RE: CHANGE ORDER PROPOSAL REQUEST #1 5/10/19

MARTIN LUTHER EVANGELICAL LUTHERAN CHURCH – RESPONSES FROM GARY BORROR – ARCH.

REV-1 5/23/19

EXHIBIT  
SKETCH #1

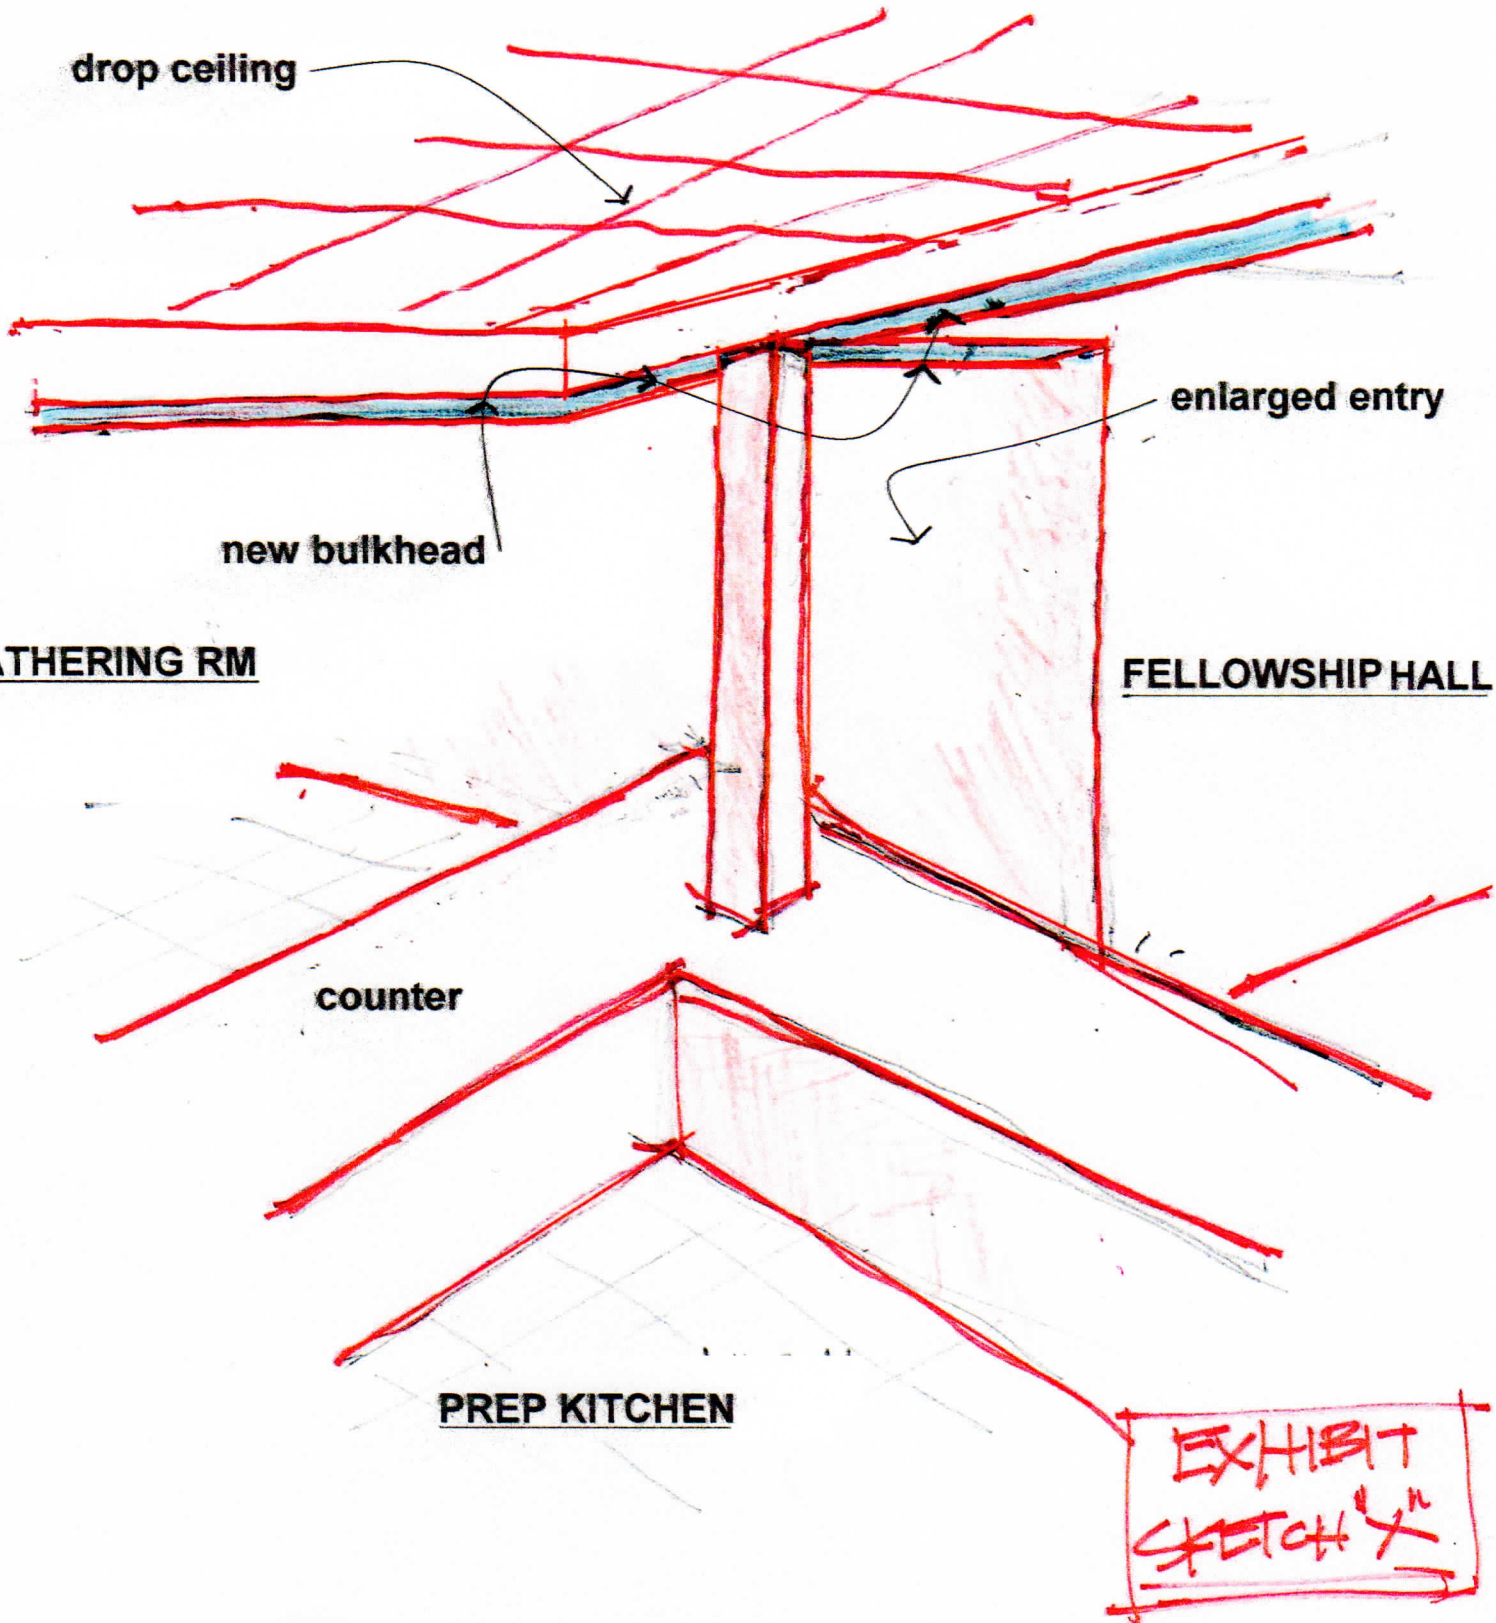
7. \* Fellowship Hall Doorway  
Open doorway up to ceiling, removing headers, side framing, leaving only req. wall for existing columns and electric conduit/switches, wrap kitchen counter around remaining structure.  
--(See A1-2 and attached plan & sketch, Exhibit X and X1, and detail N on A4-0 for changes.  
Remove all non-structural framing to the left and right of existing entry. Make height of new opening even with bulkheads at kitchen and wrap counter around corner of remaining structure. (see drawings and attached Exhibits X,X1)

drawing title: DEMO/EXISTG PLNS  
NEW WORK at  
SANCTUARY BLDG

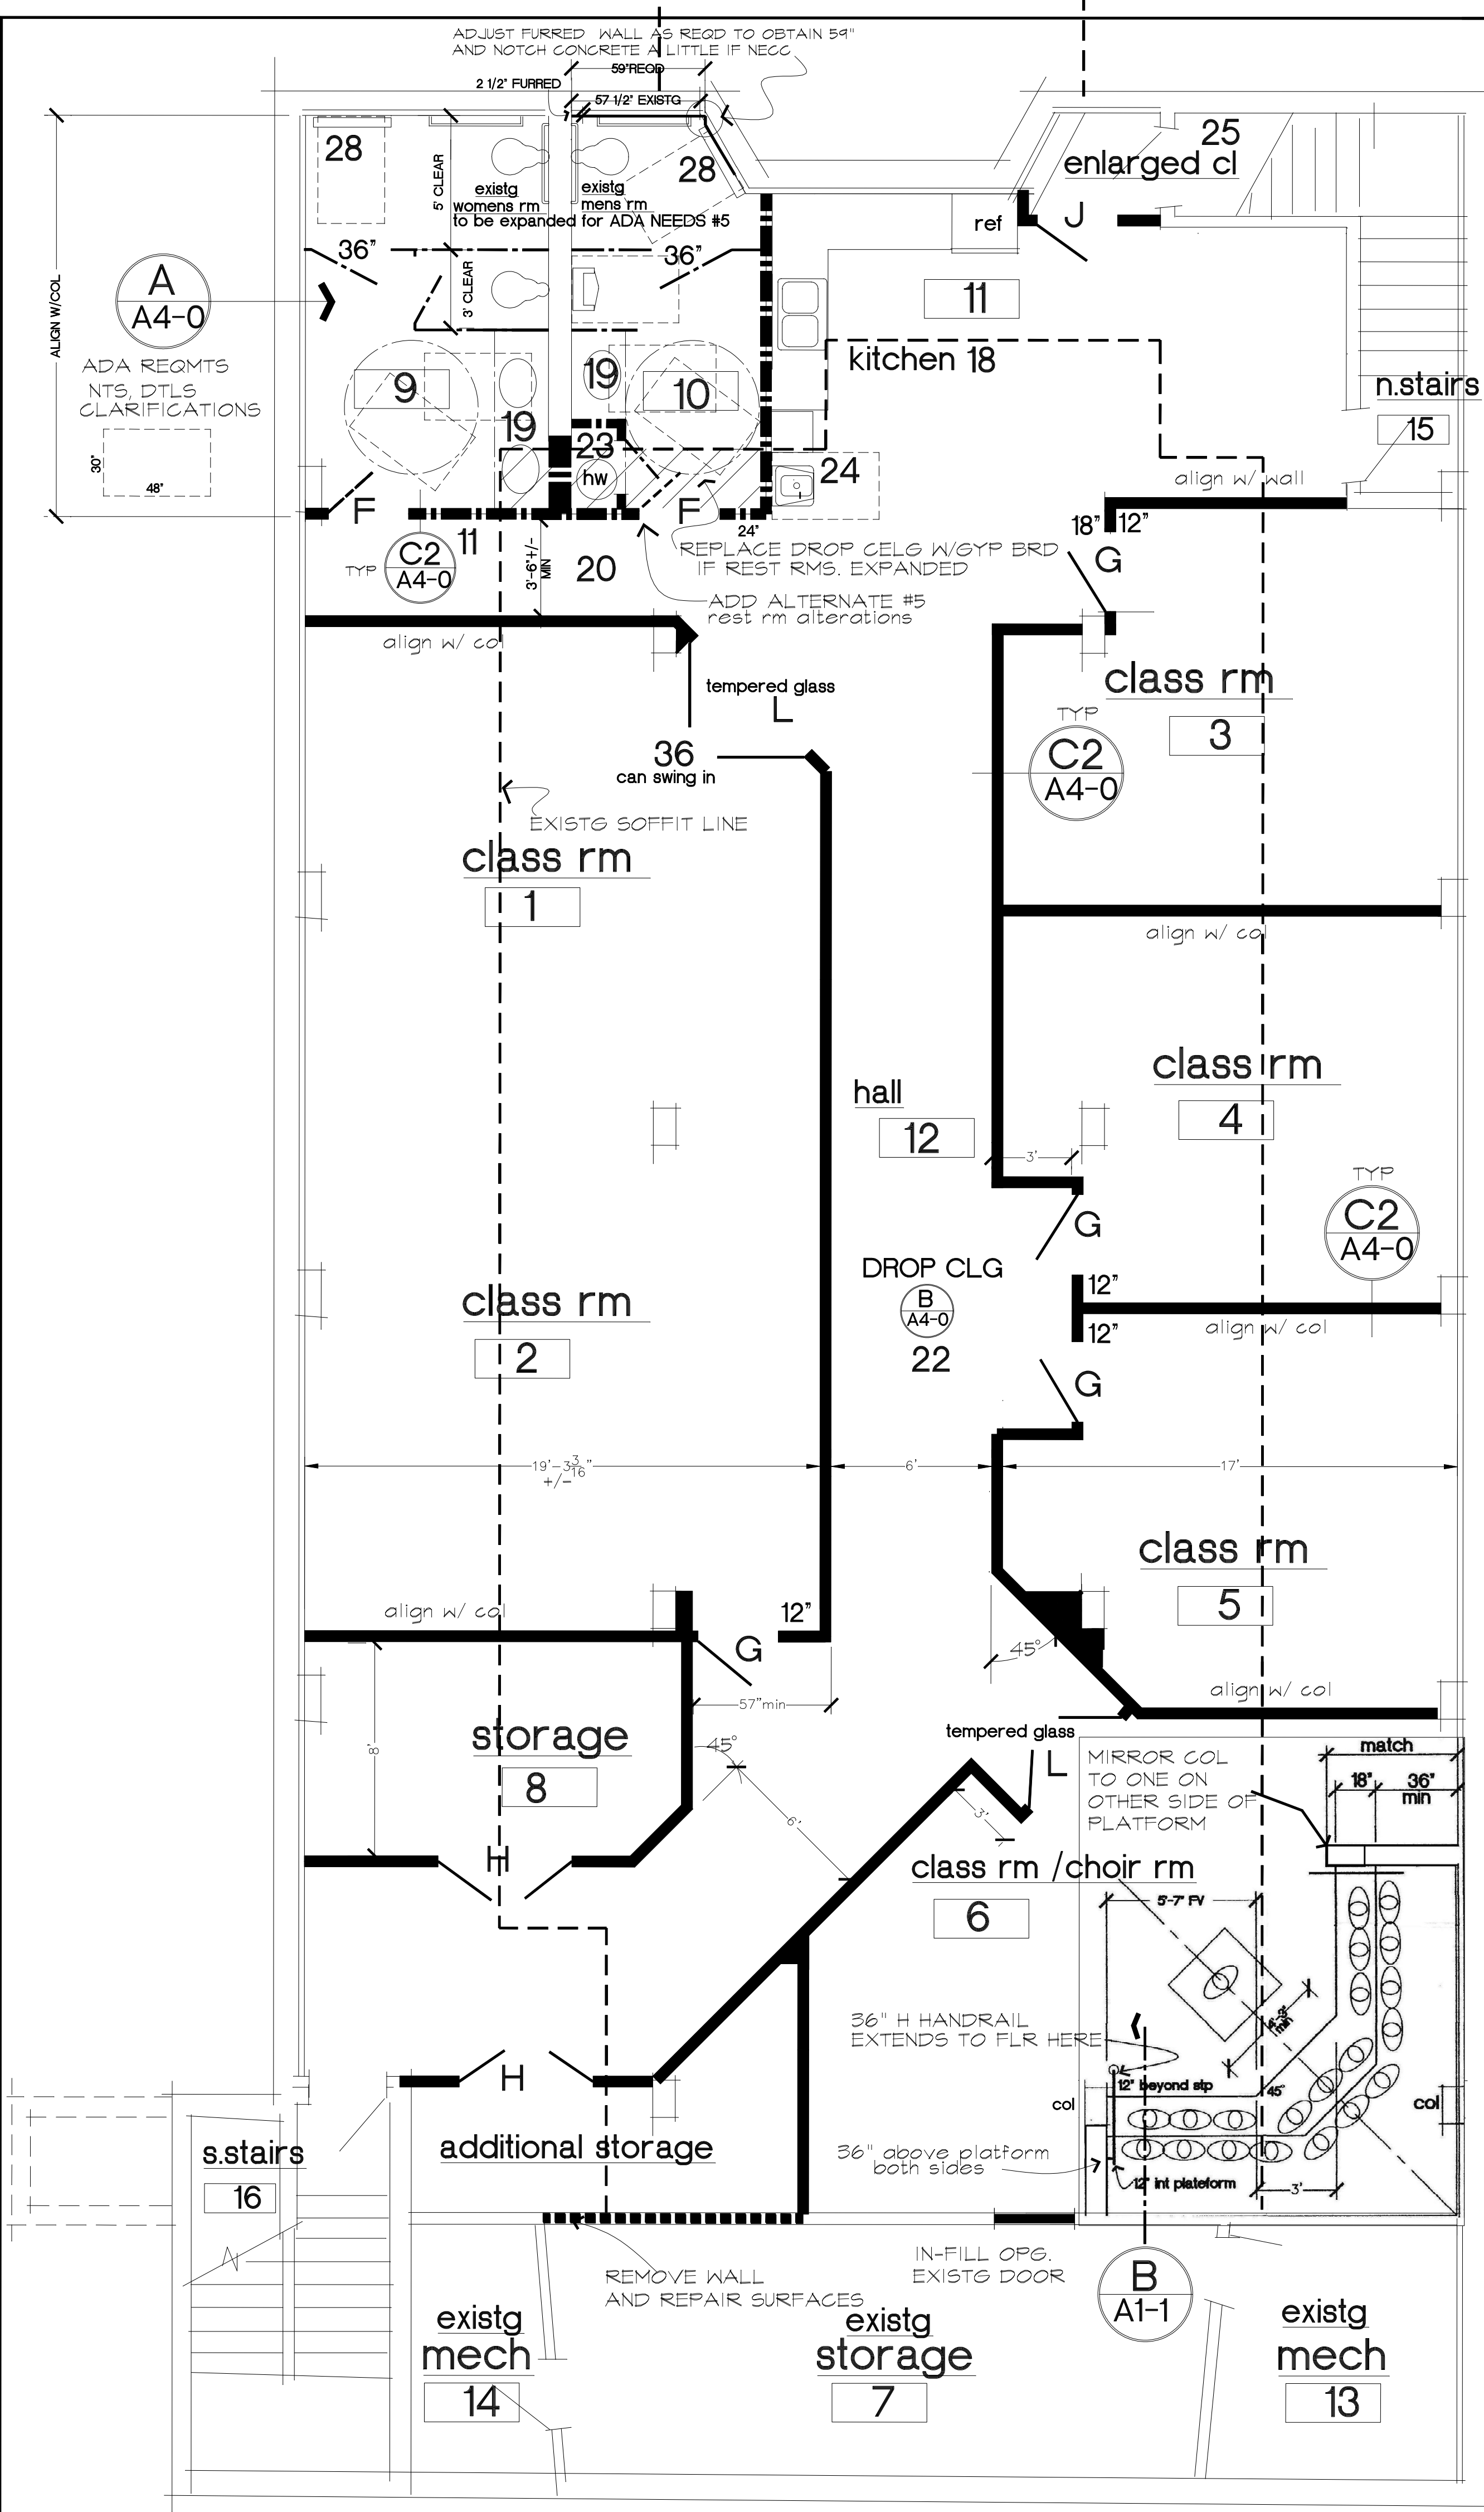
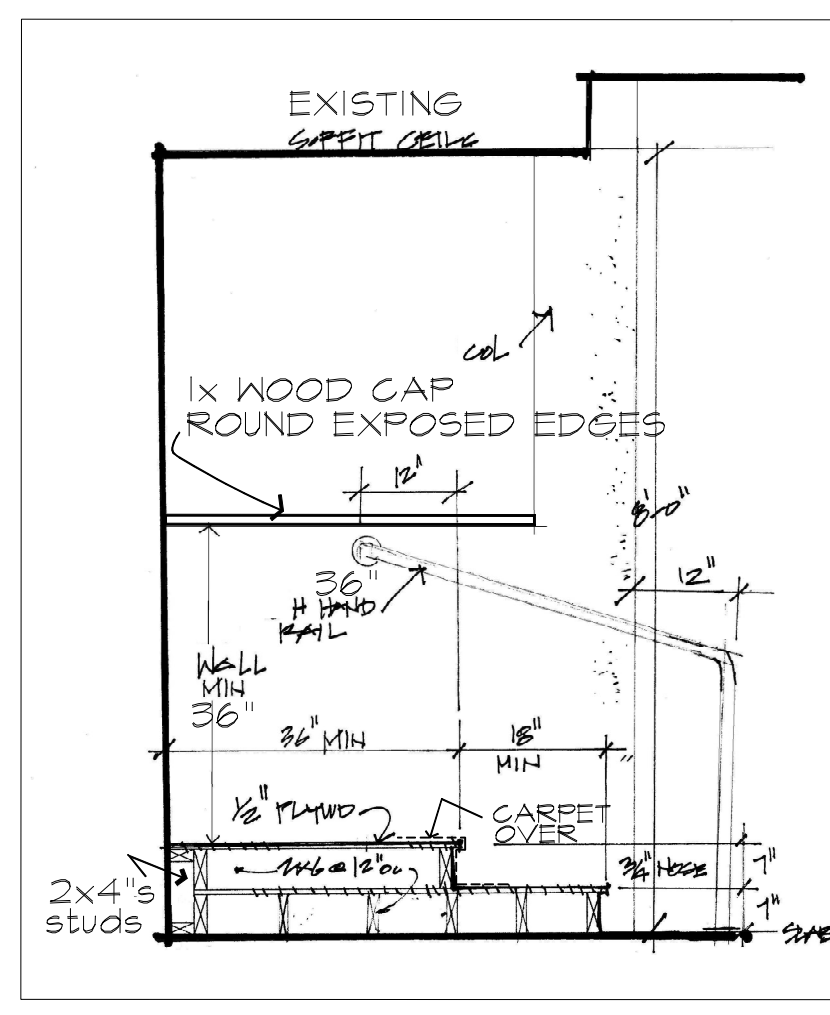
--(See A1-2 keynote 4 added with above items for replacement door and enlarging opening also new door designated on Door Schedule on A1-2 as "P" and listed on A0-2 Specifications under New Doors, Exterior Replacement Door "P" at Anteroom N. Door)

- KEYNOTES
- 1.REMOVE PARTITIONS
  - 2.CONVERT STORAGE/PRINTING ROOM TO NURSERY
  - 3.REMOVE KITCHEN AND APPLIANCES
  4. Enlarge the Breakroom Entrance North Door.

- a. Remove the existing door, frame, and hardware. Enlarge the opening for a new door.
    - b. Provide new lintel over door. Provide new column beside door to carry lintel.

- e. Patch walls and ceiling after demolition/installation.
  - 5.REMOVE DOOR AND FRAME
  - 6.REMOVE PARTITION TO OPEN NEW KITCHEN TO FELLOWSHIP HALL  
PROVIDE LINTEL 12" MAX SPAN - (2) 1-3/4" X 11-1/4" 1.9E TI MICROLAM LVL
